| FED.ROAD DIST.NO. | STATE | PROJ. NO. | FISCAL YEAR | SHEET NO. | TOTAL SHEETS |
|---|---|---|---|---|---|
| HAWAII | HAW. | I-H3-1(72) | 1991 | ADD. 60 | 521 |

# GRADING PLAN
## H3 - KANEOHE INTERCHANGE
## STA. 333+62 TO STA. 344+00

# GRADING PLAN
## RAMP D
## STA.1083+57.76 TO STA. 1091+00

# GRADING PLAN
# RELOCATED LIKELIKE HIGHWAY
# STA. 0+00 TO STA. 9+00

# GRADING PLAN
# RAMP TK
## STA. 22+00 TO STA. 28+75.68

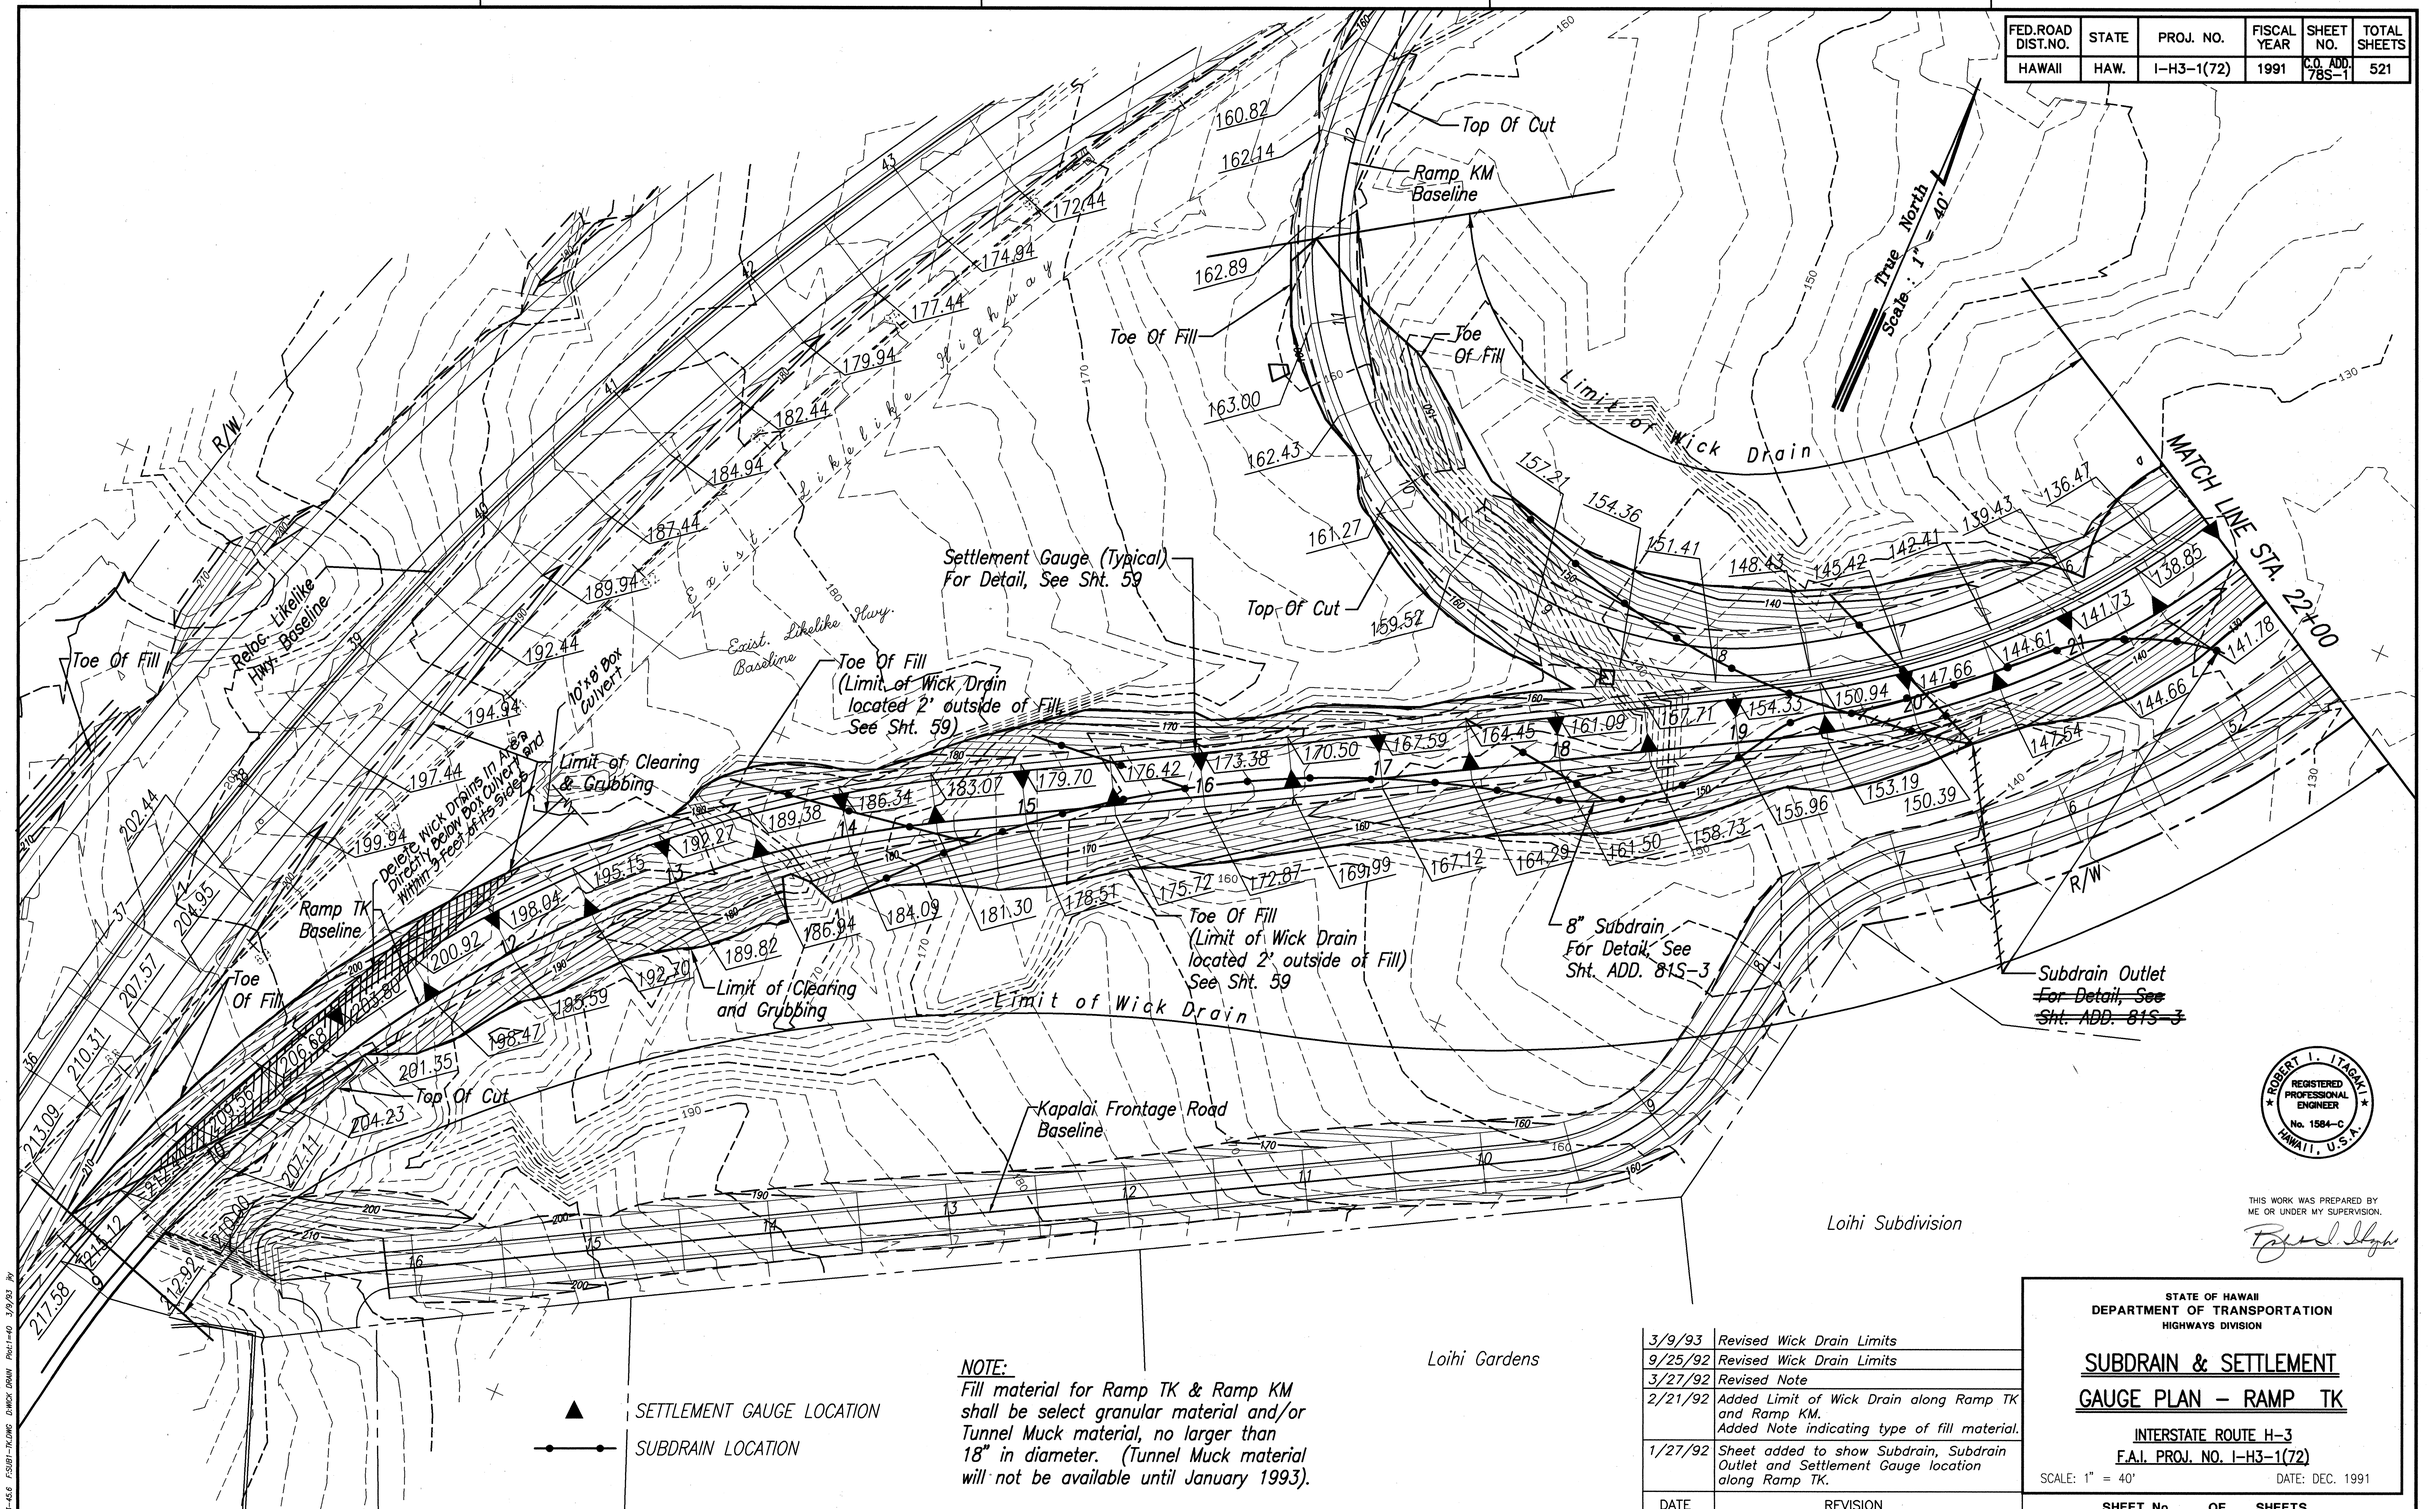
| 1/14/94 | Revised Shoulder Radius at Likelike/ Kahekili Intersection |
| 2/17/93 | Revised Edge Pav't Radius and Added Channelizing Island at Ramp TK/Reloc. Likelike Intersection. Revised Ramp TK grades along rt. shoulder @ 25+00 & 25+50. |
| 1/27/92 | Revised Limits of Clearing and Grubbing. |
